MBHP_OPL3 module modifications, the 5V option

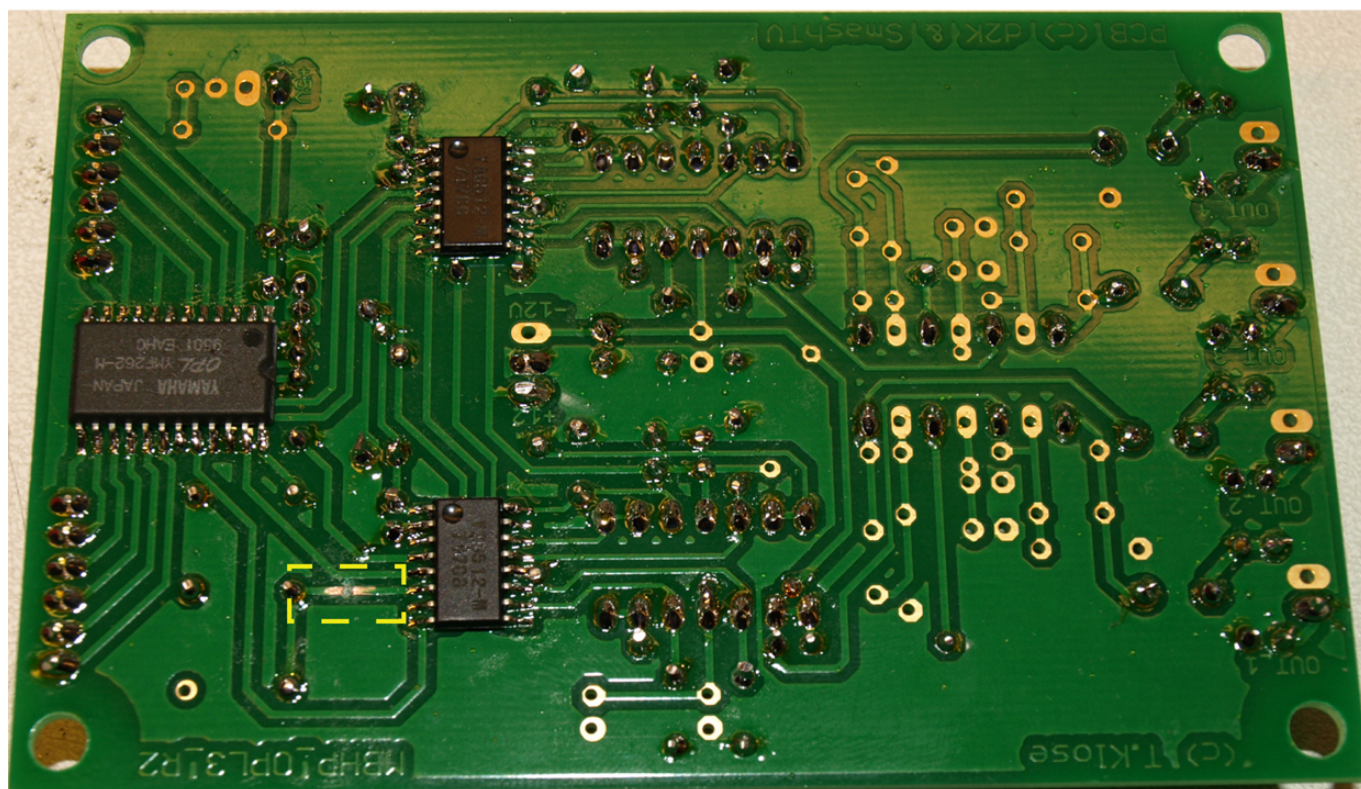
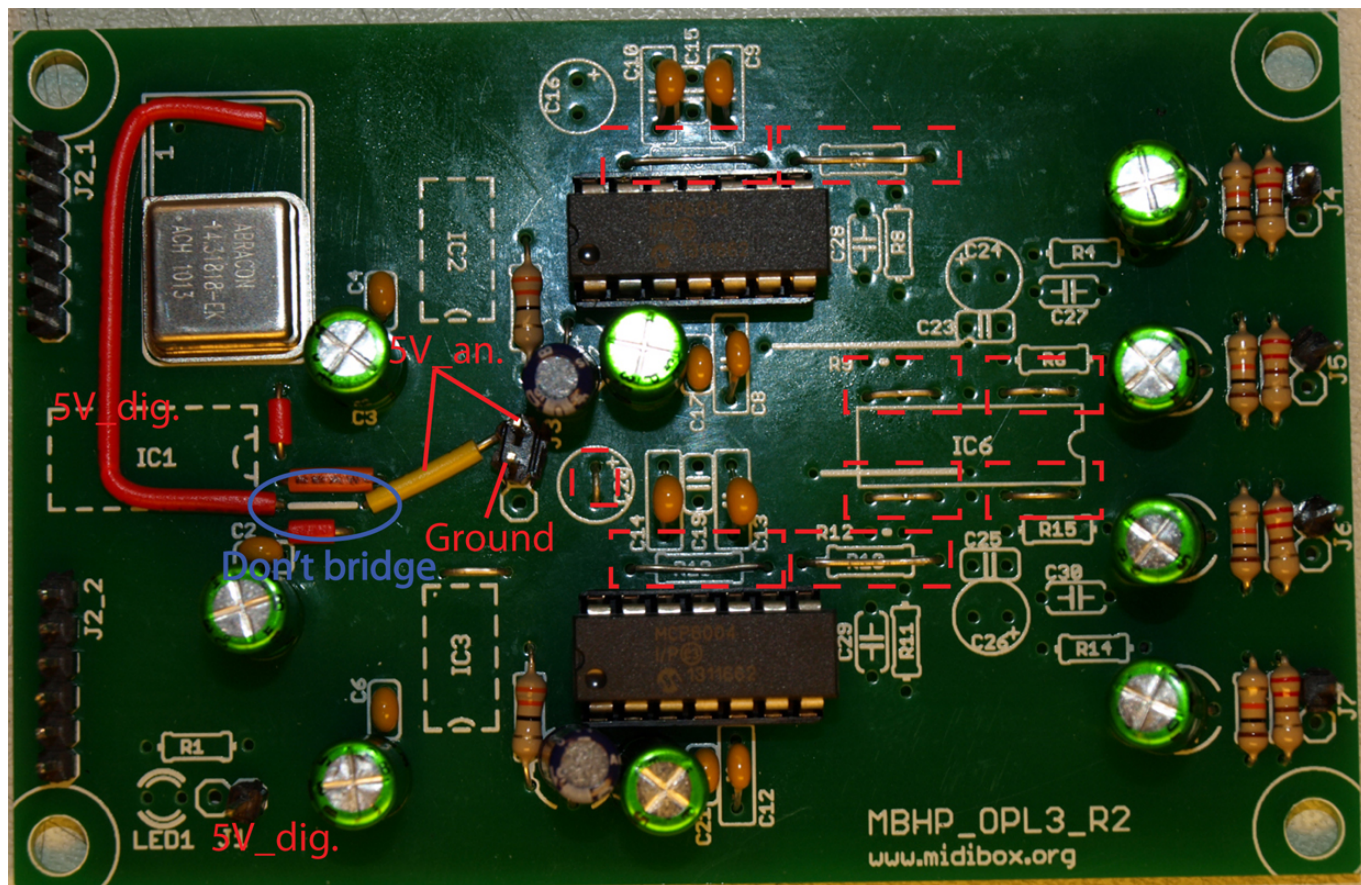
- Replace R5,R7,R10 and R13 with jumpers
- Bridge IC6 pads 1&3, 5&7, 8&10 and 12&14
- Leave out:
IC6
R4, R6, R8, R9, R11, R12, R14, R15
C15, C16, C19, C20, C23-C30
- Bridge C20 pads (to supply Ground for the op-amps)
- Leave out bridges to IC6
- Use MCP6004 for IC3 and IC5
- Supply 5V to the +12V pin, and Ground to Ground

This way the second buffering stage is left out.

- Cut the trace between the 5V pin of the Oscillator and the DAC
- Leave out the middle horizontal bridge from IC1
- Connect the right pad of this bridge to the 5V pin in the middle of the board with a jumper
- Connect the left pad of this bridge to the 5V pin of the Oscillator with a jumper

See illustration
